**To:** Members of Dublin City Council  
**From:** Dana McDaniel, City Manager  
**Date:** July 27, 2017  
**Initiated By:** Megan O'Callaghan, PE, Director of Public Works  
Paul A. Hammersmith, PE, Director of Engineering/City Engineer  
Jean-Ellen Willis, PE, Engineering Manager-Transportation  
**Re:** SR 161/Riverside Drive Roundabout Operations Review

Figure 1: Existing Northbound Lane Assignments

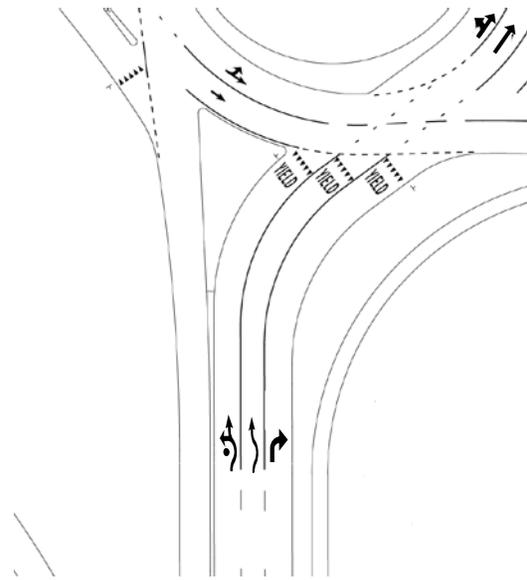
Analysis was performed for various lane assignments for both the 2017 traffic volumes and projected 2030 traffic volumes. This work identified an important lane assignment change to the northbound entry. All other entries will remain as they are in terms of the number of lanes and their lane assignments.

The existing lane assignments are shown in Figure 1 below. Based on the sensitivity testing and analysis, proposed lane assignments are shown in Figure 2.
